BARWON SOLAR FARM - PLANNING PERMIT PA2201886 SECTION 50 AMENDMENT APPLICATION

Urbis continues to Act on behalf of Elgin Energy, in relation to the above planning permit application to construct and operate a renewable energy facility at 1000 Little River-Ripley Road, Little River.

PROPOSED CHANGES

Figure 1 Additional Sound Barriers

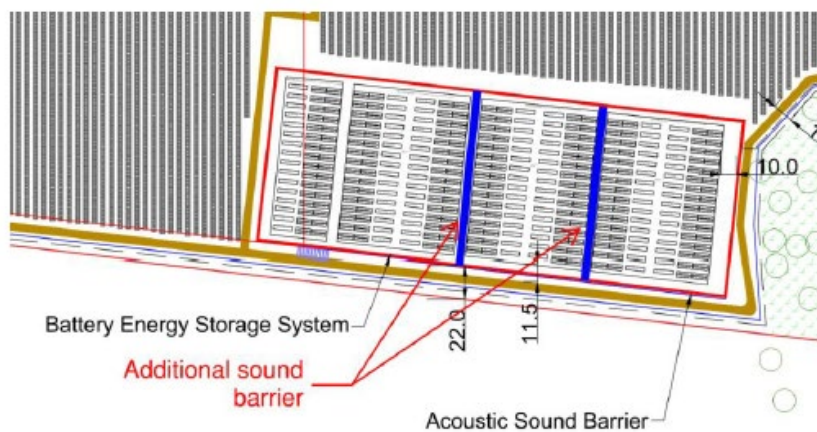
As a result of the increased capacity of the BESS, there have been some changes to the noise criteria, which has led to minor adjustments being made to the acoustic barriers around the BESS. Specifically, two intermediary barriers have been added to help mitigate the noise in accordance with EPA publication 1826.4.

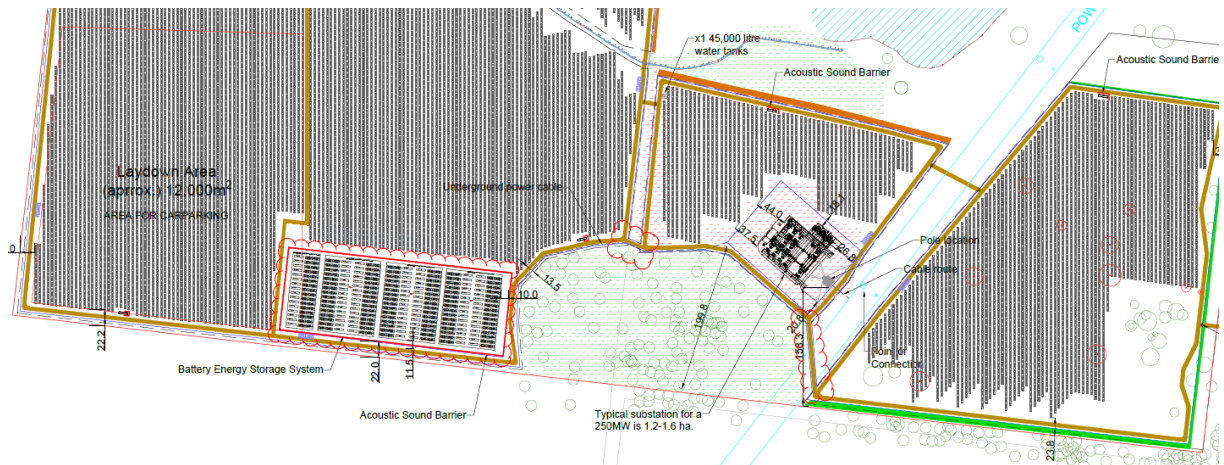
Additionally, two connecting road are proposed for improved service vehicle access within the southern region of the site. The primary function of these roads is to service and clean the panels. As these roads are not perimeter or site access roads, they are not subject to the same CFA requirements as the ring roads. As suggested by Richard Creswell of Ecological, the additional 2 small tracks will be graded to match the existing topography and therefore will also not have any significant impact on surface water flow paths nor depths and velocities under the modelled conditions.
